Replies to EA1415-01 Notice of proceeding - risk assessment review and response

These replies to MVEIRB with detailed point-by-point explanations of CNZ comments are in follow-up to the MVEIRB Notice of proceeding -risk assessment review and response, dated December 8th . The document was issued after receiving the Letter CZN to MVEIRB re: Risk Assessment, dated Dec 5 2016.

We refer to the November 18, 2016 risk assessment (RA) report, and the November 30, 2016 RA ‘cover letter’, prepared by Oboni Riskope Associates Inc. Canadian Zinc Corporation (CZN) has reviewed these. In our opinion, there is a need to reconsider and adjust the assumptions made in the RA. Following this, an addendum should be prepared with the

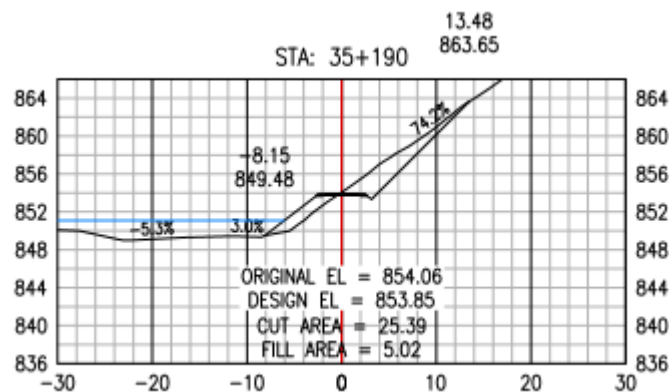
4 1st . para., Oboni notes that the real life accidents in their examples were driver-related, and not due to hazards. They also state that they “found a similar result in this study”. This conflicts with their comments elsewhere regarding landslides and rock falls, in which they say these can cause accidents, e.g. 2nd. last para., “high velocity, small volume events can generate high risks”. It is again worth noting that the evidence indicates that these events are not currently thought to be significant, but if they are found to be, upslope protection would be implemented.

There is no conflict. Although there were no geo-hazard related accidents in the road examples, that does not mean such an accident is “impossible”. Also, high velocity, small volume can generate high risks if the product of their probability and consequences is high.

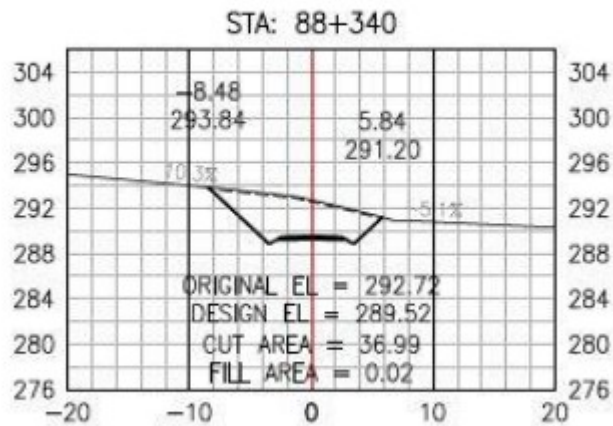
The minor cut described at km 80.3 to 80.41 is declared to be in Stratification V, documented to date, as far as we have understood, by a segment Stratification V, km 88-89 from the Allnorth May 10th report, which was supposed to be representative of the whole segment.

We note however that Dec 5th letter and May 10th report seems to contain Stratification V limits (km 86.3 to km 90.3) which are in conflict with the table above.

We would welcome a clarification related to the existence of the cross section below, copied from the Dec 5th letter and in particular the double labelling of the location (80.3-80.41, compatible with the table above) and the Sta 88+340 appearing on top of the cross section (which would be compatible with May 10th Stratification V).

We note that this new information does not substantiate that the RA requiring an update since the cross sections are indeed necessary to determine the Consequence Class, but the likelihood of off-road excursion is evaluated using the longitudinal profiles and plan views.
